This study evaluates the performance of reanalysis, regional mesoscale simulations, and purpose built wind datasets in a promising yet sparsely observed offshore environment near Hawaii. Using a year-long lidar buoy deployment off the eastern coast of Oahu, it characterizes the local wind resource and validates four datasets (ERA5, UH-WRF, NOW-23, GWA3) at different spatial resolutions. The region's persistent trade winds make it favorable for wind power, but limited hub height observations underscore the need for accurate data. By comparing multiple products in this uniquely characterized setting, the work is relevant to the sector and appears suitable for publication pending the revisions below.

We are deeply grateful for your time and thoughtfulness in reviewing our manuscript and providing valuable suggestions for improvement. We are thankful for the opportunity to share an updated draft that reflects the guidance provided by yourself and an additional reviewer.

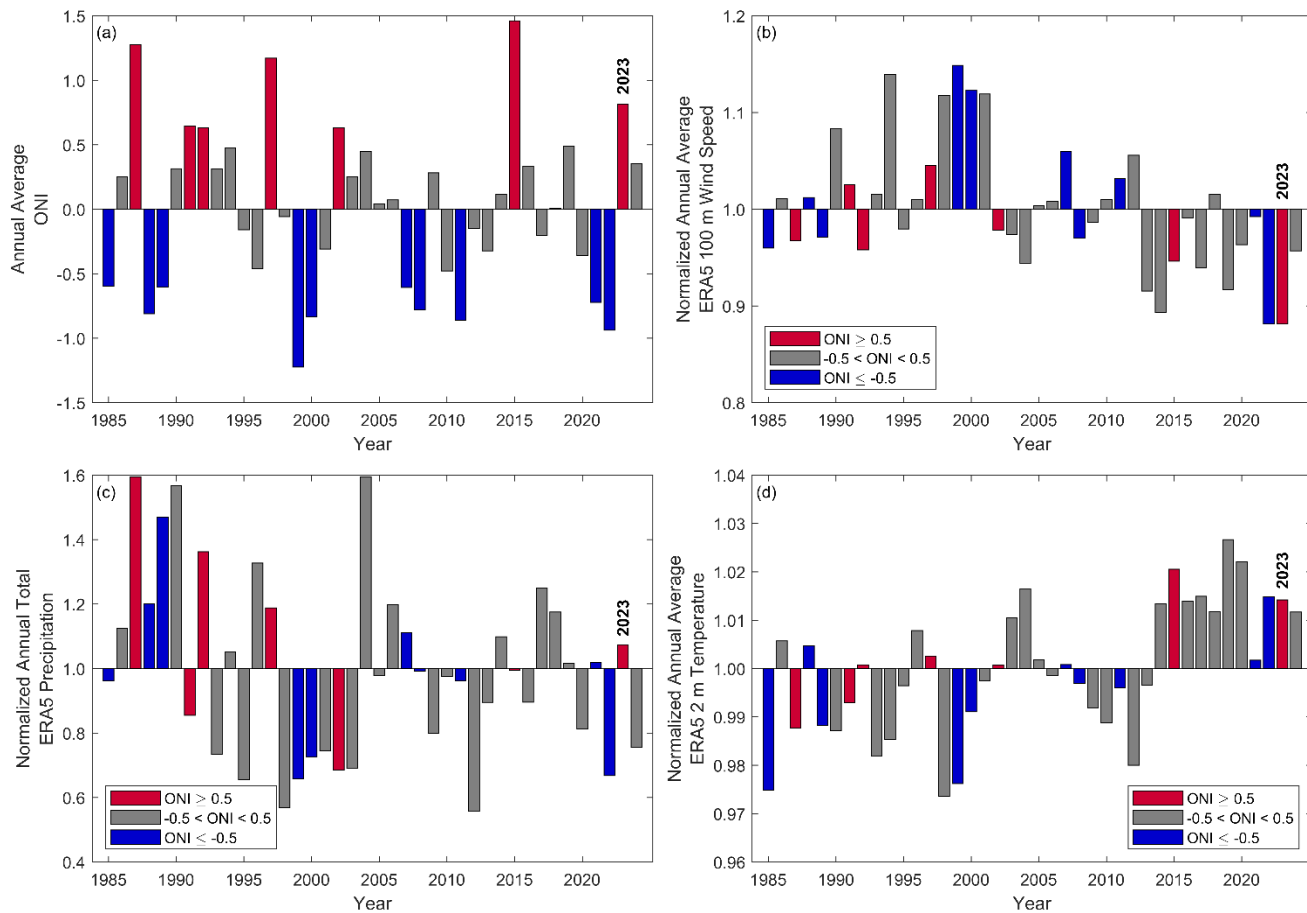
Prior to the responses to your specific concerns, which follow, we wished to share one major update to the manuscript that stemmed from analysis suggested by both reviewers: Based on the recommendation to evaluate whether the observation year 2023 was a typical or atypical wind resource year at the deployment location, we established that it was a highly atypical year that did not allow for proper evaluation of the nonconcurrent datasets NOW-23 and Global Wind Atlas. Therefore, we have removed them as analysis datasets from the manuscript with the following discussion:

Lines 180-194: "Prior to comparing the O'ahu observations, which predominantly occur in the year 2023, with atmospheric datasets, it is imperative to provide context on what kind of meteorological year 2023 is relative to the long-term interannual wind speed variability noted at the deployment location. Utilising annual averages of the Oceanic Niño Index (ONI), we find that 2023 is categorized as an El Niño year based on the Climate Prediction Center's threshold of $\pm 0.5^{\circ}\text{C}$ (Figure 3a) (NOAA, 2025). In Figure 3b, we explore the annual average ERA5 100 m wind speeds (CDS, 2025b) between 1985 and 2024 and determine that 2022 and 2023 are tied for having the lowest annual average wind speeds over the 40-year period (annual average wind speeds normalized by the 40-year mean for both years = 0.88) while being opposingly classified as La Niña and El Niño years, respectively (Figure 3a). According to ERA5, precipitation and 2 m temperature are above average at the buoy location for the year 2023 (Figure 3c, d). The above average precipitation, temperature, and weakening of the trade winds are consistent with expected El Niño characteristics (Lu et al., 2020).

The following analyses focus on the performance of two simulation datasets that have concurrent temporal coverage with the 2023 observations: ERA5 and UH-WRF. Given the context of 2023 being a record low wind resource year east of O'ahu according to the ERA5 record, it is important to note the need for long-term, continuously updating datasets like reanalyses. Purpose-built wind datasets, like NOW-23 (2000-2019) and Global Wind Atlas (2008-2017), provide numerous years for wind resource assessment but would not represent the characteristics of an atypical year like 2023."

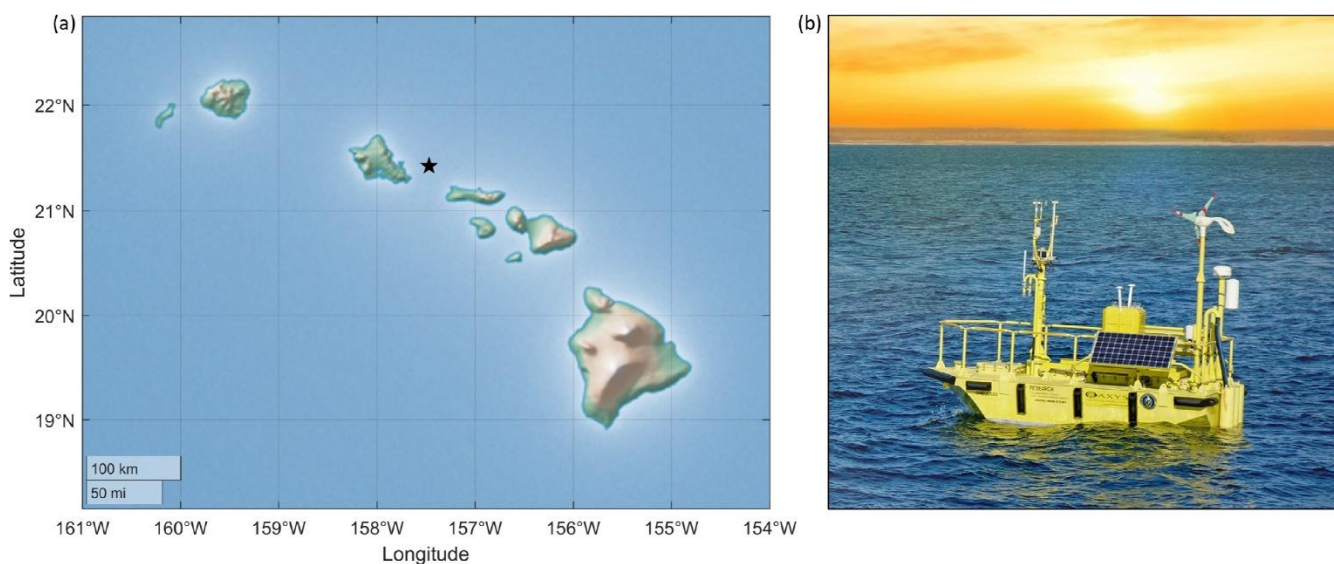
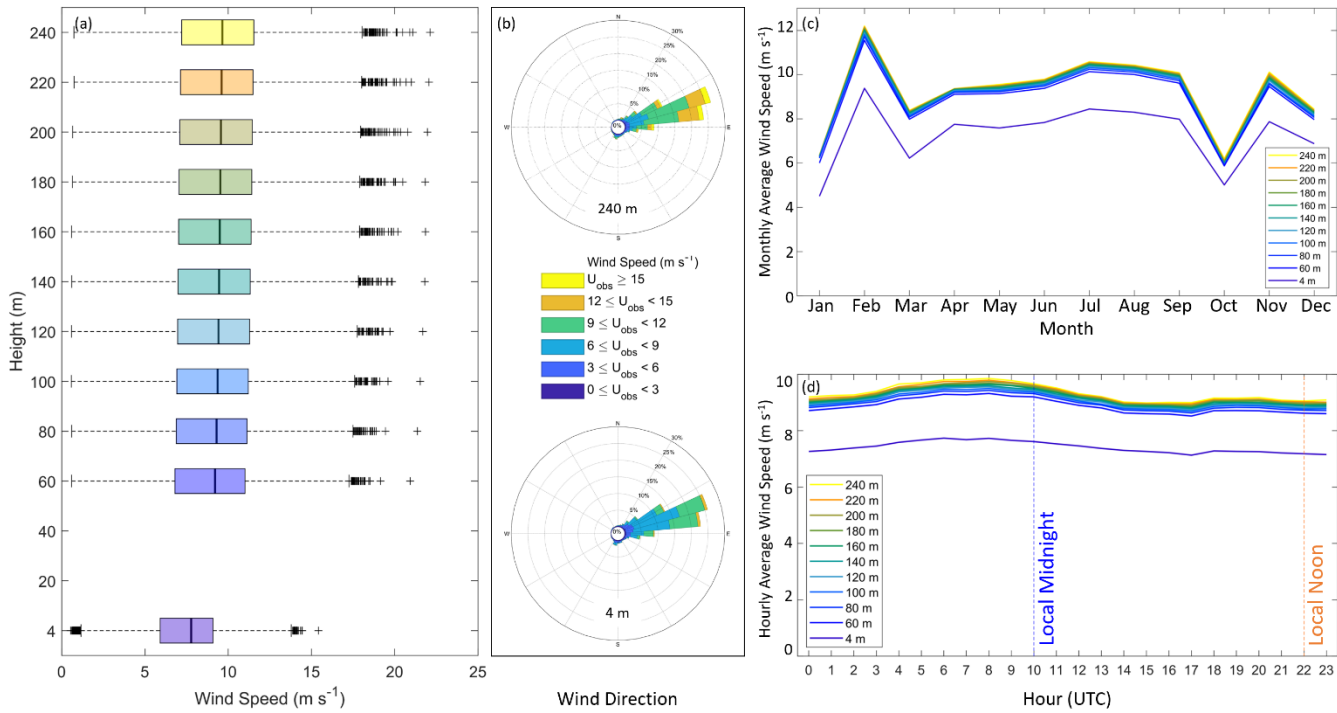
Section 2: Consider merging the opening of Section 2 with the first paragraph of Section 2.1 to present a concise summary of the observational data (source, location, period, sampling/averaging, heights, instrument/method). The rest could be moved to a new subsection (e.g., Local Wind Characterization). You could briefly summarize the key points and refer to a single comprehensive figure that combines the already shown plots 2a and 2b, and adds (c) monthly and seasonal means and (d) the diurnal cycle, rather than exhaustively listing numbers. Any additional technical details should go in the Appendix.

We appreciate your recommendation to truncate the amount of detail in Section 2. We have taken your suggestions to merge the opening of Section 2 with the first paragraph of Section 2.1, establish a new subsection called Local Wind Characterization with a single comprehensive figure, and remove extensively listed numbers as follows:

DOE owns multiple AXYS WindSentinel™ buoys, including the buoy deployed for resource assessment off the coast of O’ahu which is outfitted with a Leosphere Windcube v2 lidar system and surface meteorological and oceanographic instruments (Figure 1). While the DOE buoy observations during the Hawai’i deployment are discussed extensively in Appendix A, we provide the key characteristics of the lidar wind measurements to set a baseline for comparison with the wind datasets. Many of the observed characteristics are also found throughout the results to provide context for the evaluations of wind dataset performance. The DOE buoy was deployed approximately 25 km off the coast of O’ahu between 1 December 2022 and 15 December 2023 (DOE, 2025a, b, c) (Figure 1). This study focuses on the wind data measured by the lidar aboard the buoy at every 20 m between 60 m and 240 m. Following the quality control performed as discussed in Appendix A, lidar data recovery for the deployment period is 98% or higher for all heights between 60 m and 240 m.

For the overlapping period covering the buoy deployment, ERA5, and UH-WRF (1 January – 15 December 2023), annual average wind speeds range from 8.87 m s^{-1} at 60 m to 9.34 m s^{-1} at 240 m with very little shear across the profile (Figure 2a). The observed winds predominantly source from the east-northeast with very little veer across the profile (Figure 2b). The observed 2023 seasonal and diurnal variations in the lidar wind speeds are presented in detail in Section 3.1, but briefly, significant variation is noted for the month-by-month transitions (Figure 2c) while the diurnal wind speed cycle transitions smoothly from hour-to-hour (Figure 2d)."

Figure 3. ERA5 and UH-WRF wind speed (a) correlations, standard deviations, and CRMSEs, and (b), (c) distributions at the Hawaii buoy location during the overlapping period of 1 January 2023 – 15 December 2023.

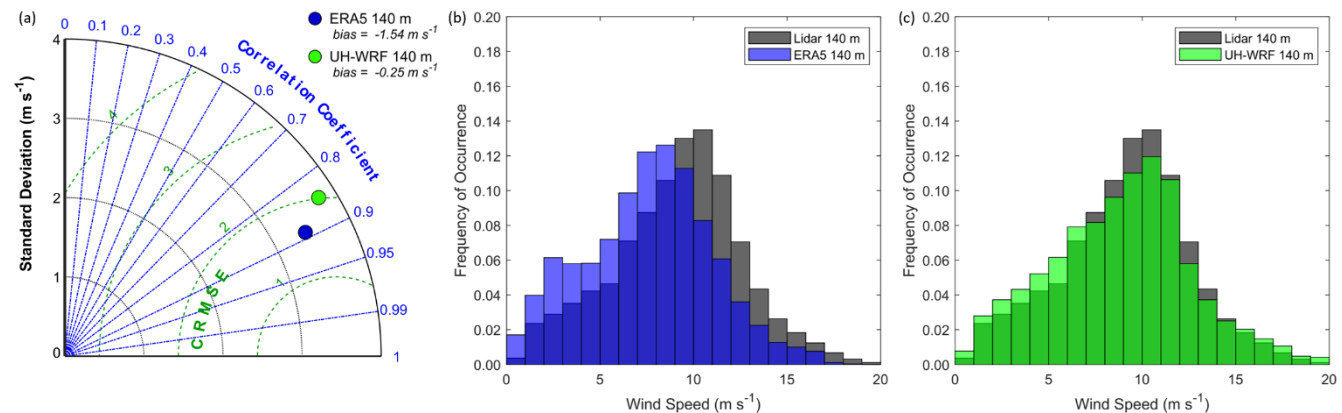
Figure 3: There is no plot 3d.

Thank you! We have removed “(d)” from the caption.

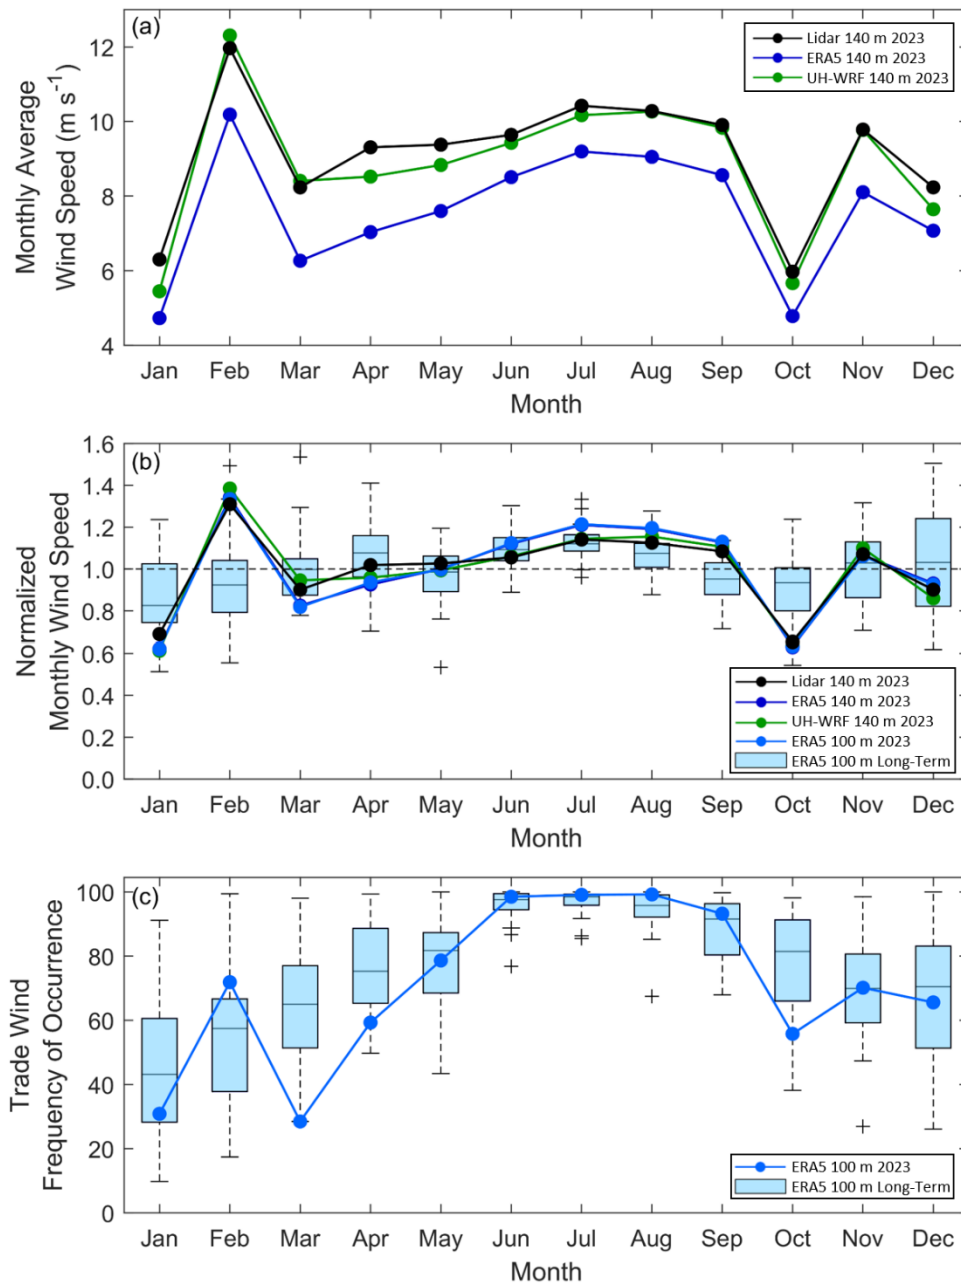
Fig. 5: State normalized by what and its relevance in the text.

We have updated the caption to read “Monthly average wind speeds normalized by the annual average wind speed” and Lines 236-239 as follows:

“Looking at the monthly wind speeds normalized by the annual average wind speed from the 2023 deployment observations and the simulation datasets, which show similar patterns, in the context of 40 years (1985 to 2024) of normalized monthly 100 m wind speeds from ERA5 (CDS, 2025b), the 2023 seasonal wind speed cycle is atypical relative to the long-term (Figure 6b).”

Figure 10. (a) Distribution of TI at 140 m during the Hawaii lidar buoy deployment, (b) observed TI according to observed 140 m wind speed, and (c) ERA5 and (d) UH-WRF 140 m wind speed bias according to observed TI.

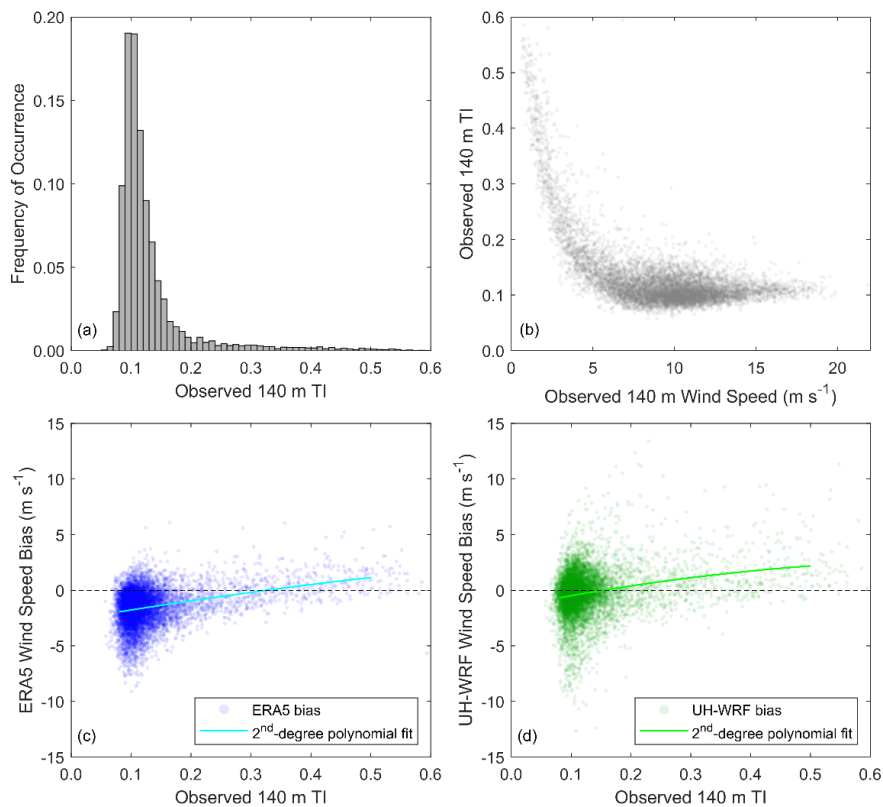
Section 3.2: Add one sentence explaining why testing different atmospheric stability conditions is relevant. Also, state explicitly that you use air-sea temperature differential as a proxy for stability and note the limitations.

Both reviewers had concerns about the air-sea temperature differential as a proxy for stability; therefore, we reworked Section 3.2 (3.3 in the updated manuscript) by replacing the air-sea temperature analysis with a discussion on the observed turbulence intensity at the lidar buoy location and the performance of the models according to TI. We hope that this analysis, using the 1-Hz lidar observations at hub height, is a more useful and

acceptable analysis than exploring wind speed performance at hub height relative to parameters at the surface. Lines 311-324:

“3.3 Wind dataset performance according to turbulence intensity

Assessing the degree of turbulence at a location of wind energy development interest is advantageous for establishing generation expectations, particularly in a waked wind farm environment (Hansen et al., 2011). Therefore, it is important to define the baseline performance of datasets used for wind resource assessment according to different turbulent environments. Using the 1-Hz lidar buoy observations from the Hawai’i deployment (DOE, 2025c), we determine turbulence intensity (TI) at turbine hub height using the ratio of the standard deviation to the mean of the 140 m wind speeds over 10-minute periods (DOE, 2025a). At the offshore O’ahu buoy location, TI values below 0.1 occur 32% of the deployment period, while the bulk of the measurements (60%) show that TI during the deployment is between 0.1 and 0.2 (Figure 10a). The sample size of TI values reaching or exceeding 0.2 is small (8% of the deployment period). For hub height wind speeds below 5 m s⁻¹, the observed TI at the buoy location follows an inverse relationship with the observed mean 10-minute wind speeds and then hovers around 0.11 for wind speeds faster than 5 m s⁻¹ (Figure 10b). ERA5 and UH-WRF exhibit trends of increasingly positive wind speed bias with increasing hub height turbulence, with median ERA5 140 m wind speed biases of -1.63 m s⁻¹, -1.44 m s⁻¹, and -0.18 m s⁻¹ and median UH-WRF 140 m wind speed biases of -0.48 m s⁻¹, -0.16 m s⁻¹, and 0.75 m s⁻¹ for observed 140 m TI less than 0.1, between 0.1 and 0.2, and at least 0.2, respectively (Figure 10c, d).”
